# HISTORIC DISTRICT COMMISSION APPLICATION FOR WORK APPROVAL

HDC2025-00446

**ADDRESS(ES):** 2491 Longfellow

**STAFF REPORT: 02/08/2024 REGULAR MEETING**

Fig 1, by Applicant: Proposed installation of the gravel pad and walkway, fence, and tree removal.

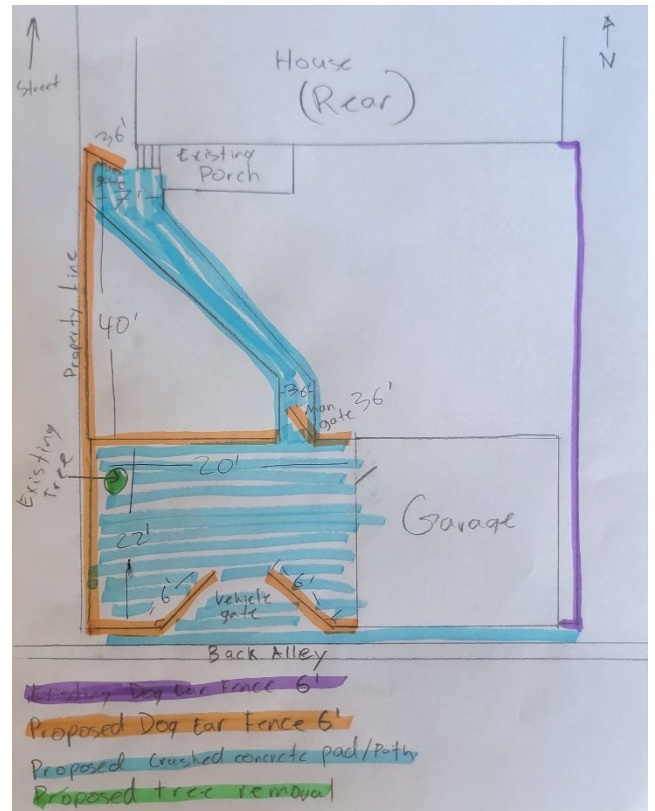
- Staff finds that the proposed gravel parking area and walking pathway are appropriate.
- Staff has the opinion that the proposed 6' wood panel fence along the rear property line and inside the backyard are appropriate as they provide continuity to existing fence conditions and follow the HDC guidelines. Staff received clarification from the applicant's contractor that the reason for waiting one year is allow the treated wood to age before being stained.

- The applicant provides HDC staff with a planting plan that offers at least one shade tree on the property to replace the removed tree.
- The applicant provides HDC staff with a paint or solid stain color for the fence.

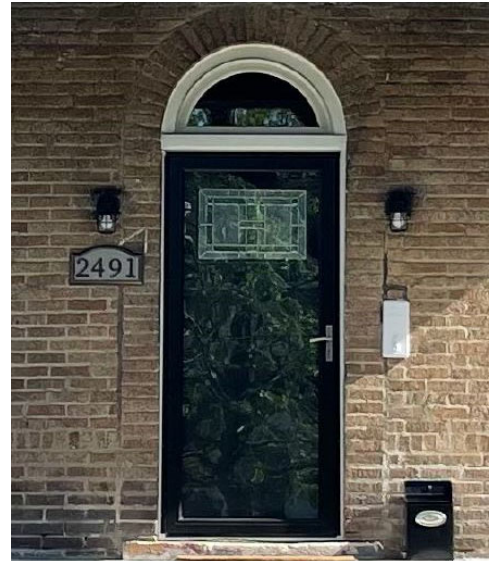
- It is staff's opinion that the pairing of the round-columns at the front porch are characteristic of the Colonial Revival architecture of the property and are character defining features of the house. Each pair, two at each end of the porch, and two side by side, totalling eight (8) columns have been reduced to four (4) single square columns, reducing the form, altering the shape and color, and modifying the design of the columns which greatly alters the porch's distinctive, historic expression. *(See photo 1, and designation image.)* However, it is staff's opinion that the repoured front porch deck, and the rebuilt front porch wingwalls and steps do meet the Standards and are appropriate.
